ADDENDUM 2

Vestavia Hill Fire Station No. 4 Expansion

DATE: **August 12, 2026**

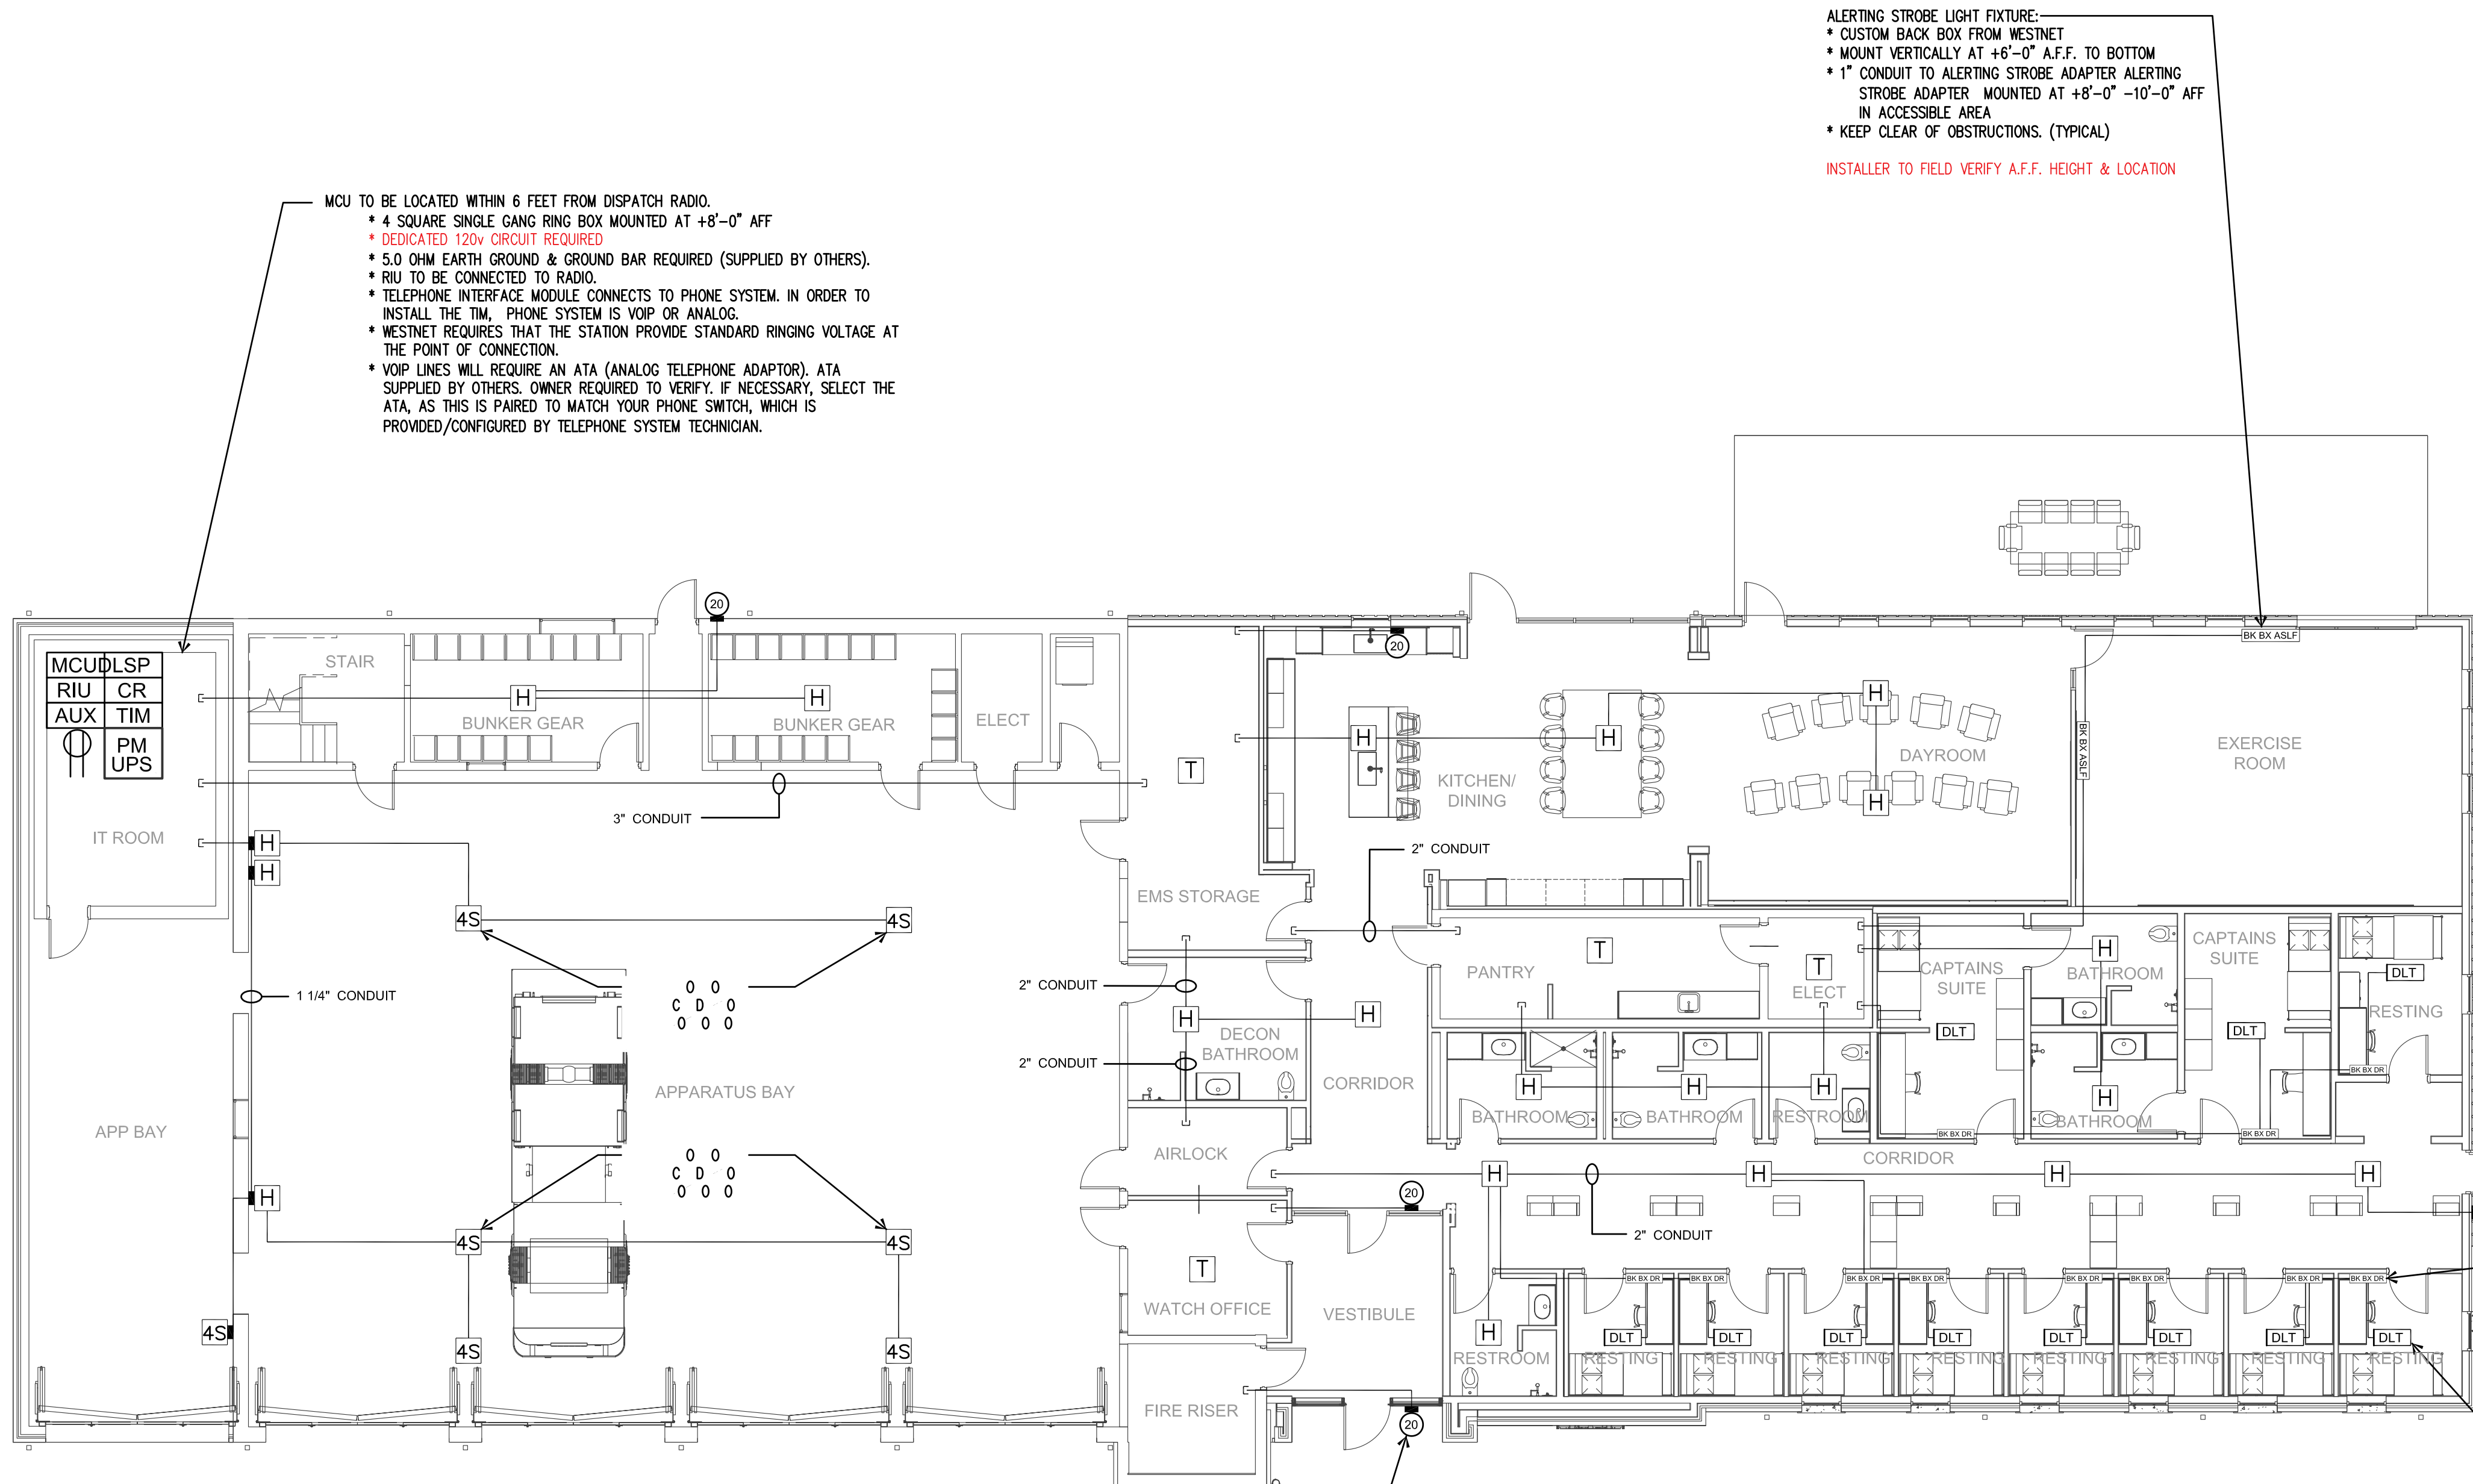
11. E-603 – FLOOR PLAN – ALERT SYSTEM CONDUIT LAYOUT PLAN:
 - a. Added drawing for alert system conduit layout to coordinate with Alert System Shop Drawings

01 HIGH POWER AMPLIFIER AND INTERIOR SPEAKER
N.T.S.
RE: WESTNET SPECIFICATIONS FOR OVERALL DEVICE DIMENSIONS.

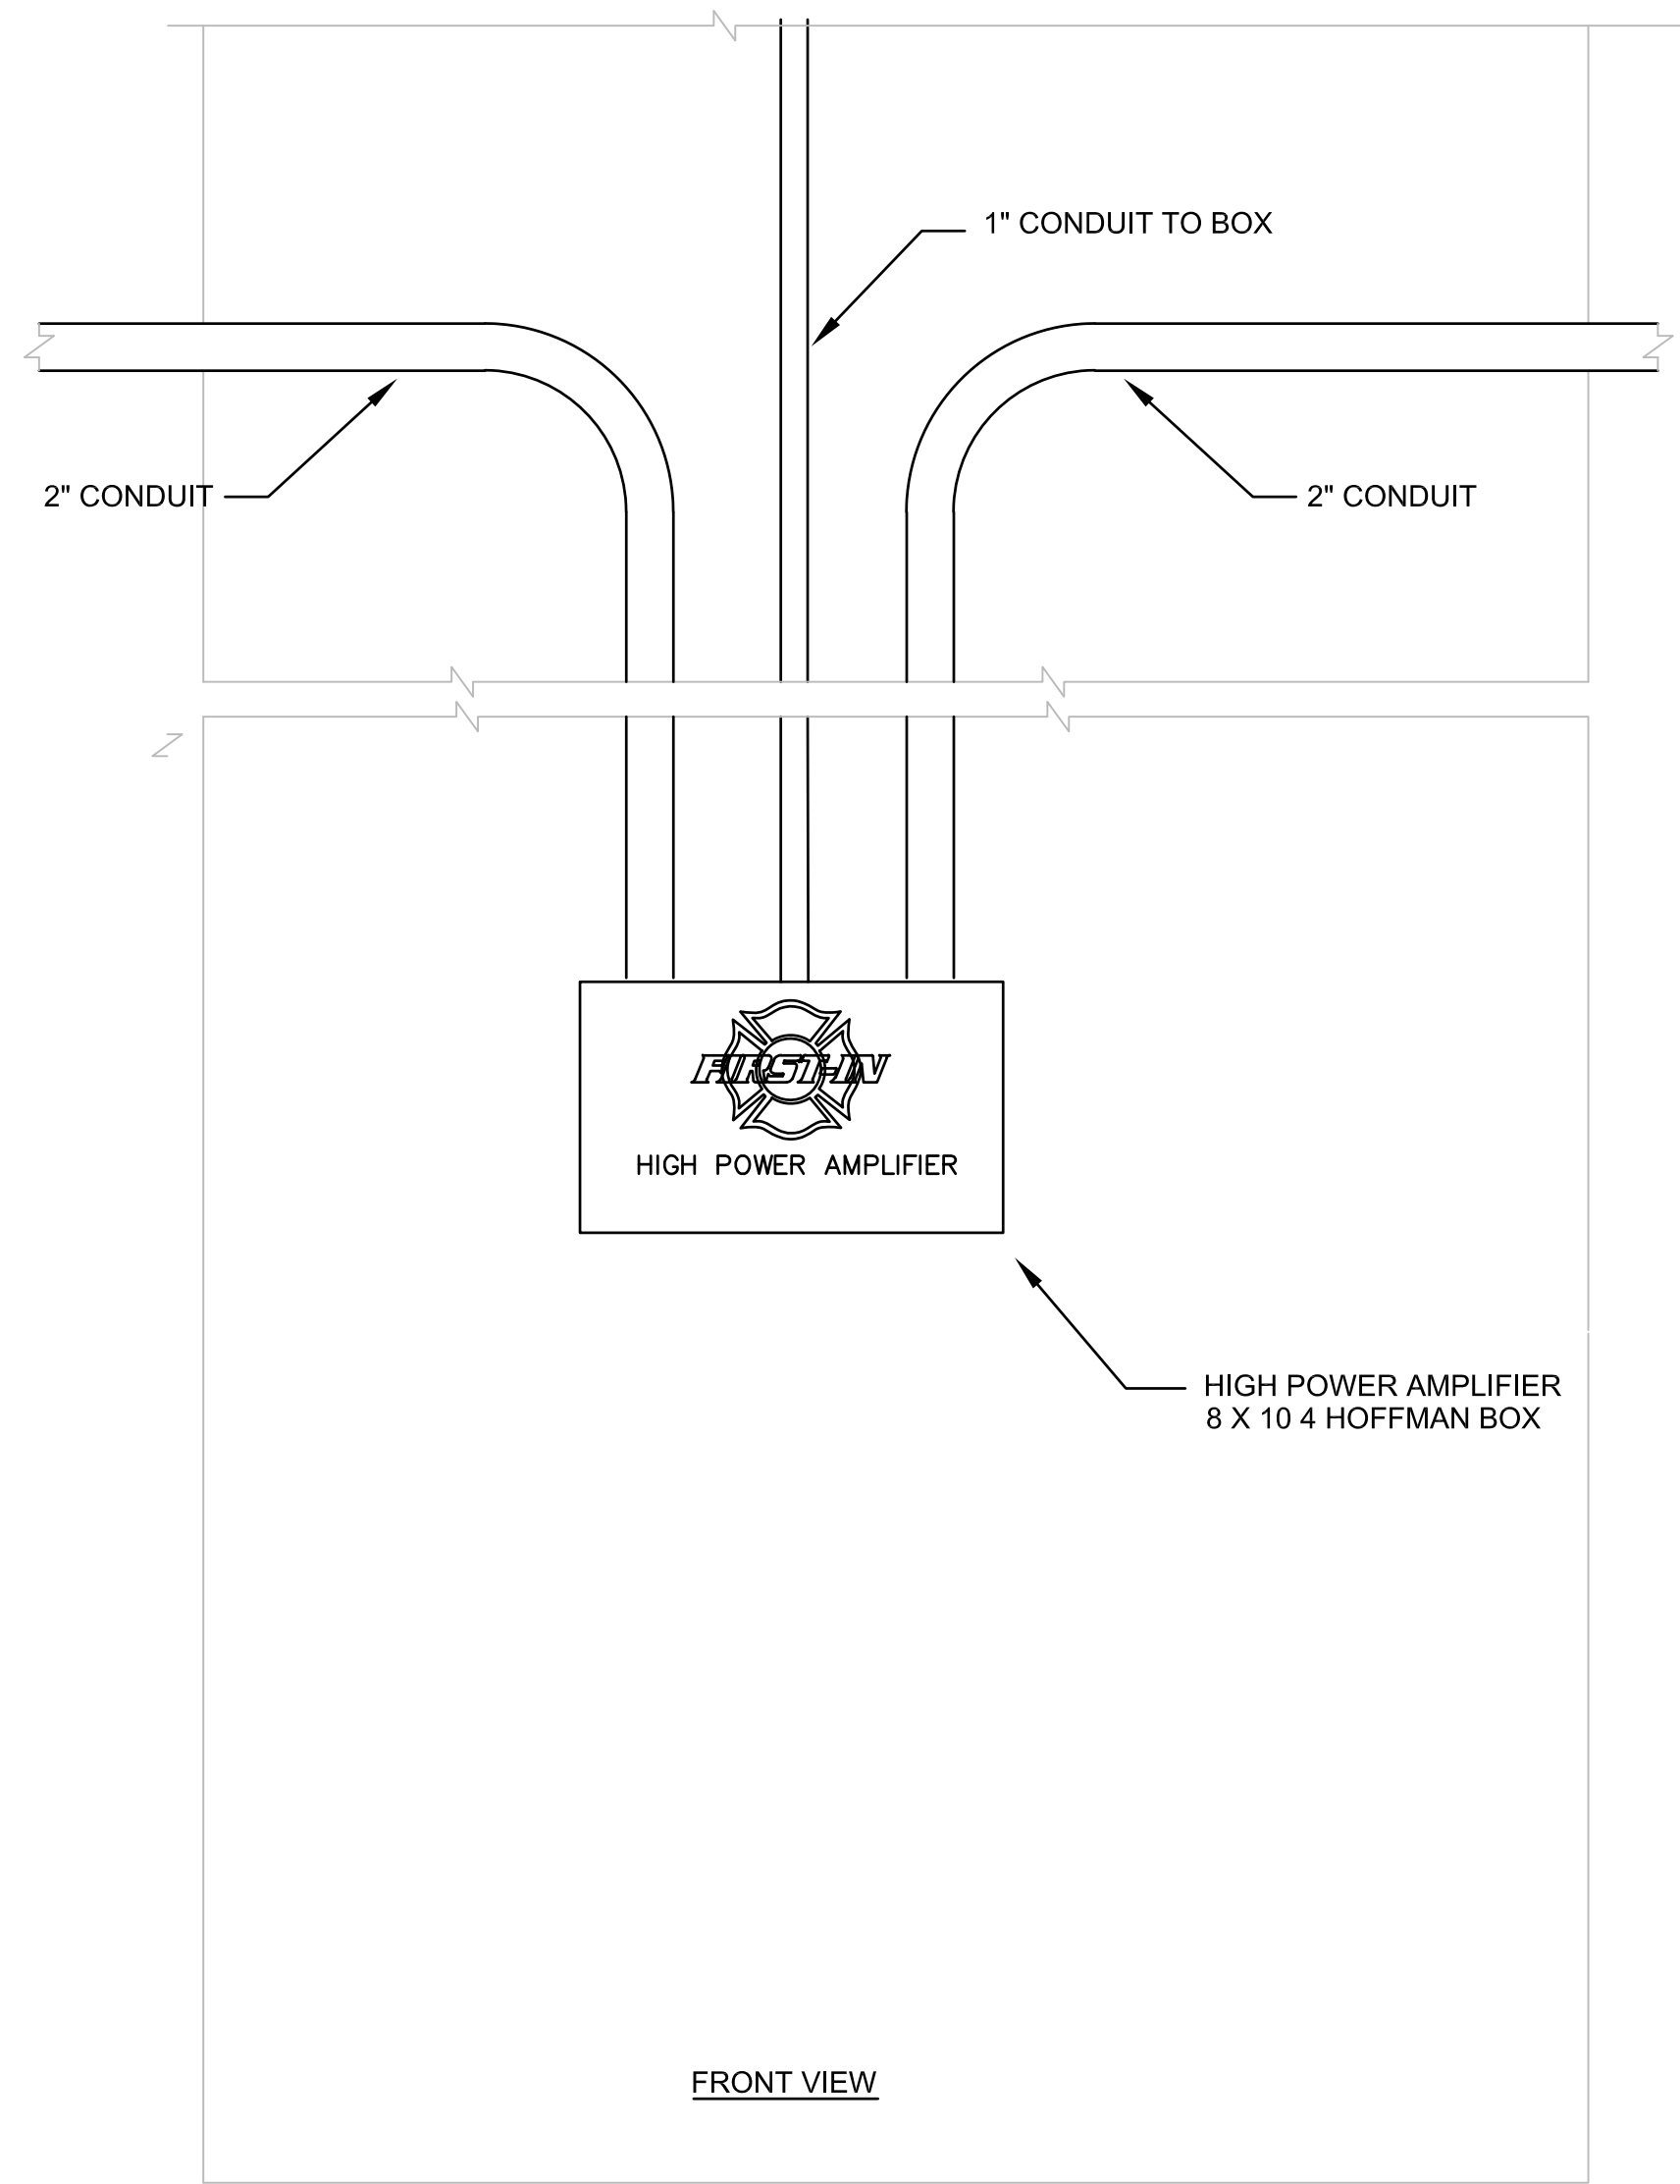
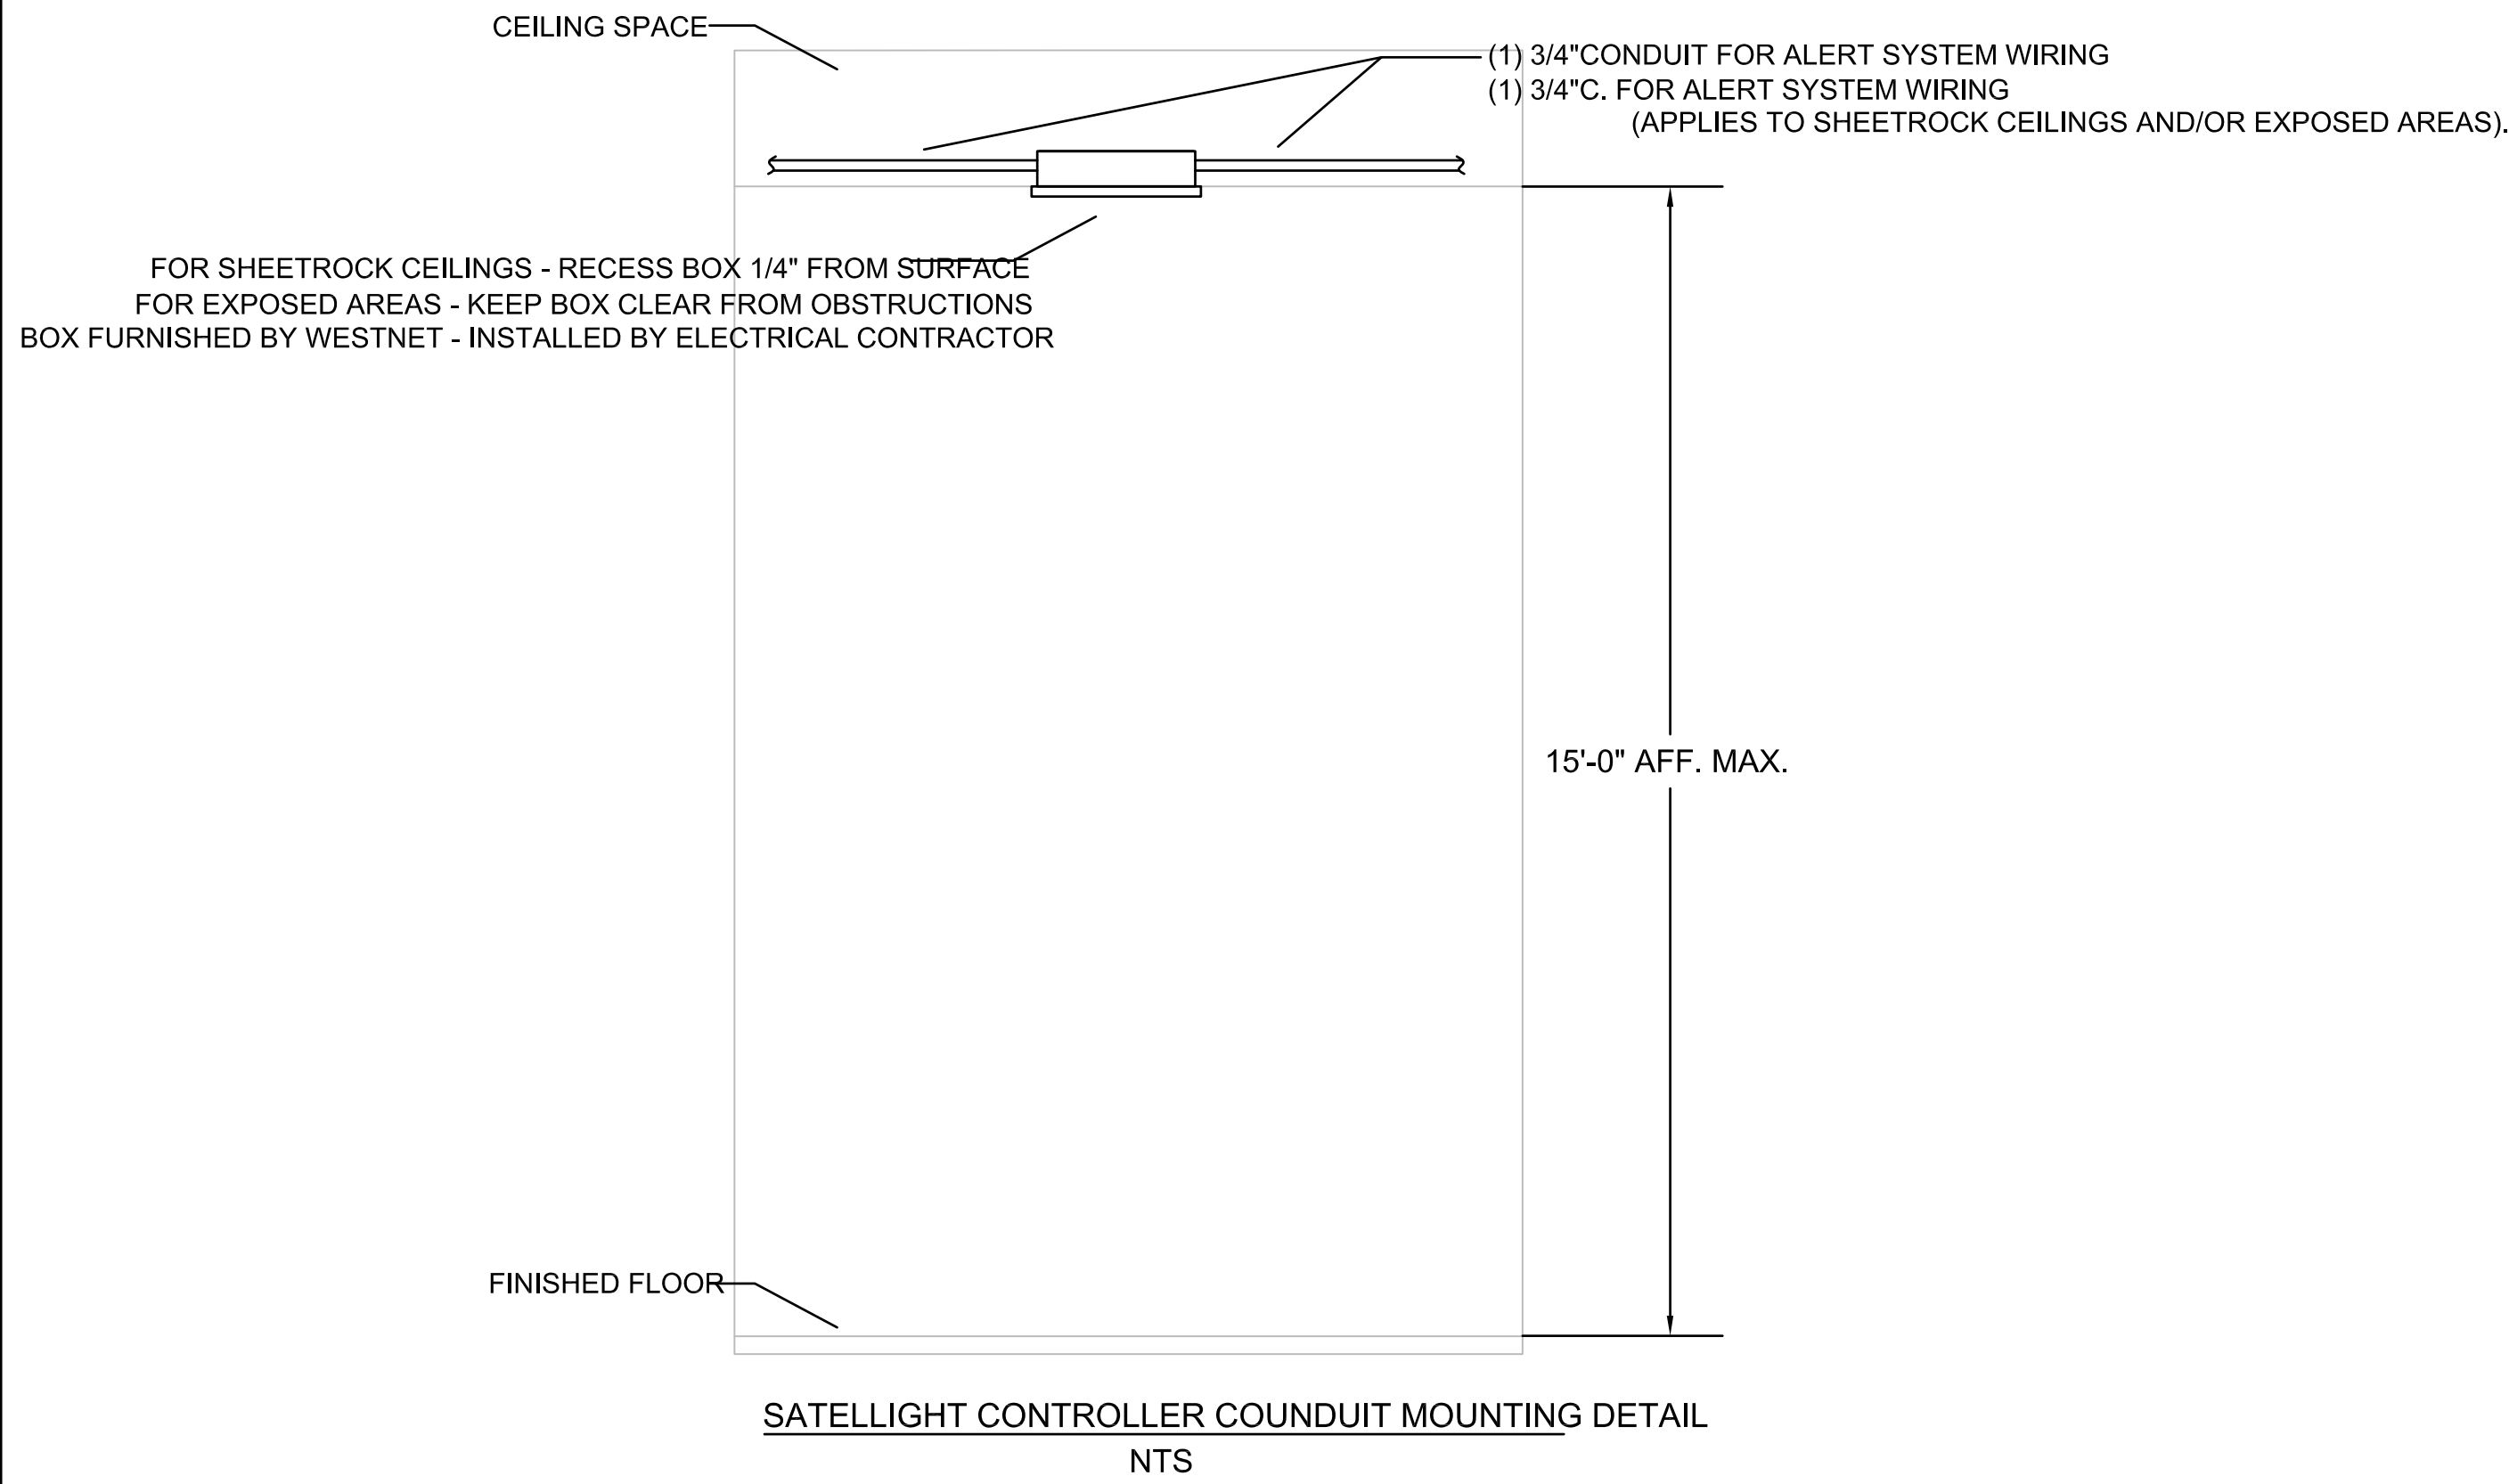
12. E-604 – ALERT SYSTEM DETAILS:
 - a. Added drawing for alert system details to coordinate with Alert System Shop Drawings.
